RE: St. Joseph Regional Port Authority 60,000 Bushel Hopper Bin & Conveyor Systems
St. Joseph, Missouri
MoDOT Project #WCI21000141
Addendum No. 1

Addendum No. 1**St. Joseph Regional Port Authority 60,000 Bushel Hopper Bin & Conveyor Systems
St. Joseph, Missouri**

EXISTING CONDITIONS, EROSION CONTROL & MAIN ELEC. FEED

Sheet C2.0A

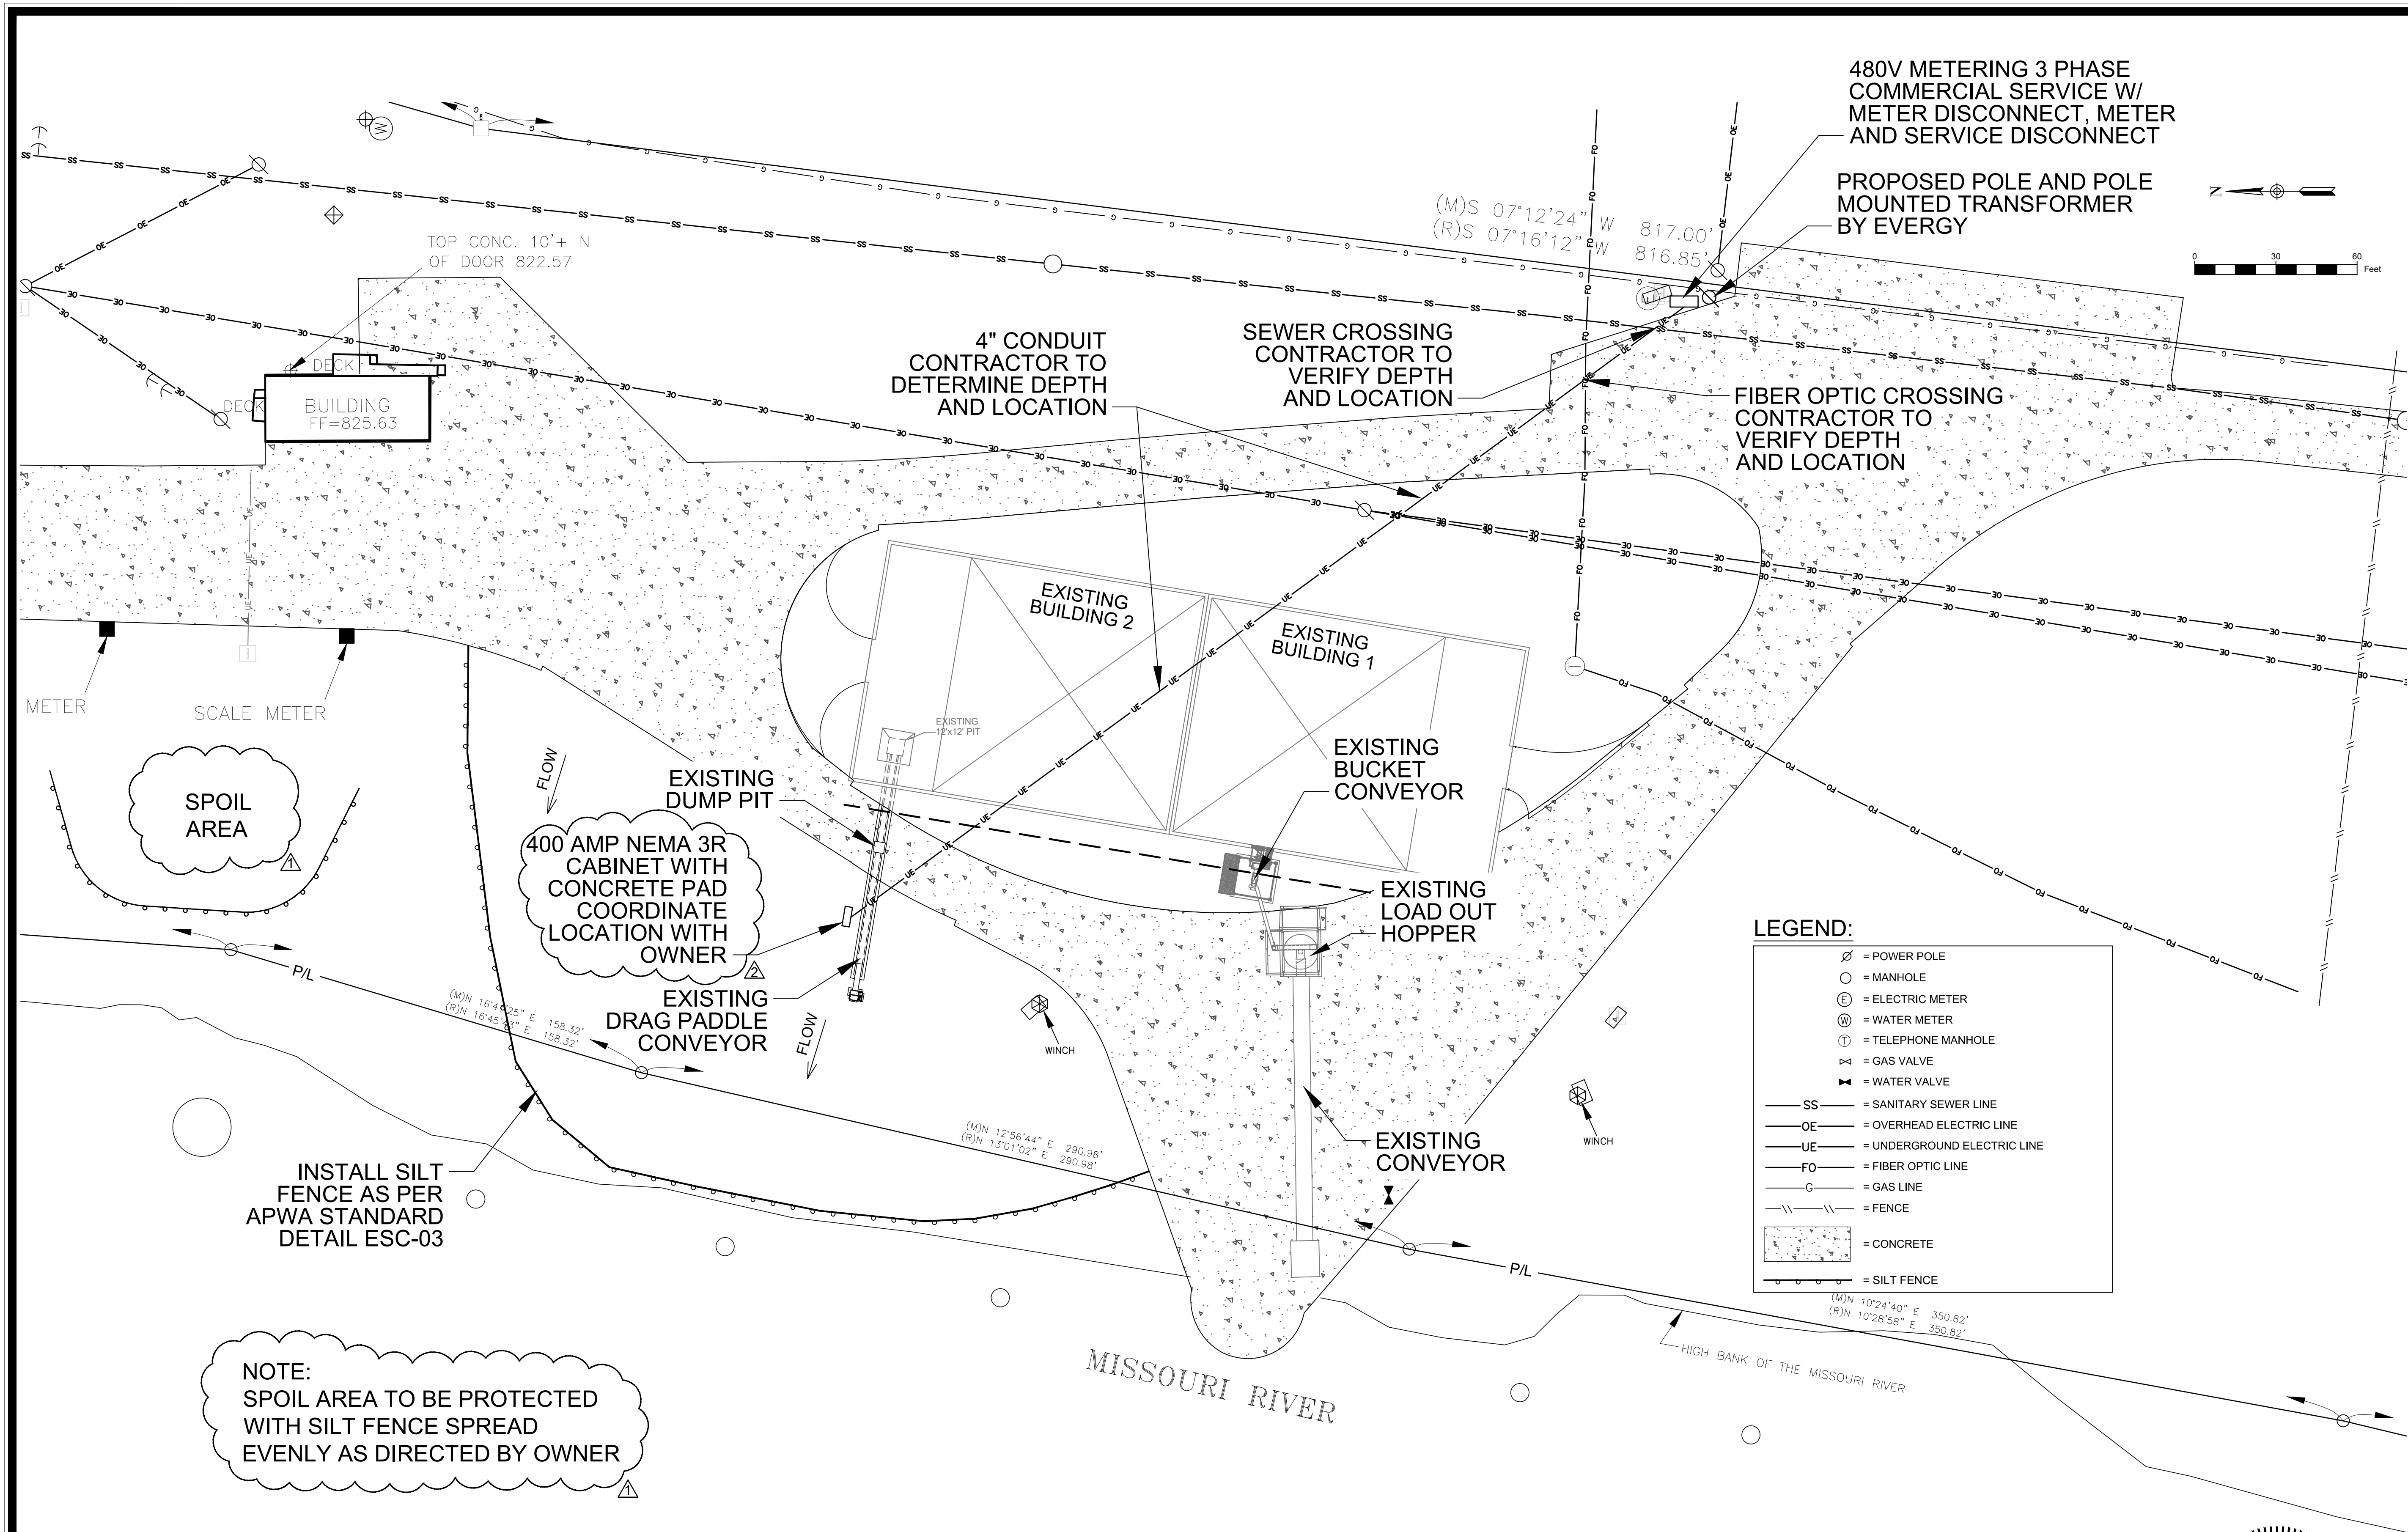
1. Replace plan sheet C2.0 with C2.0A, spoil area added including silt fence.
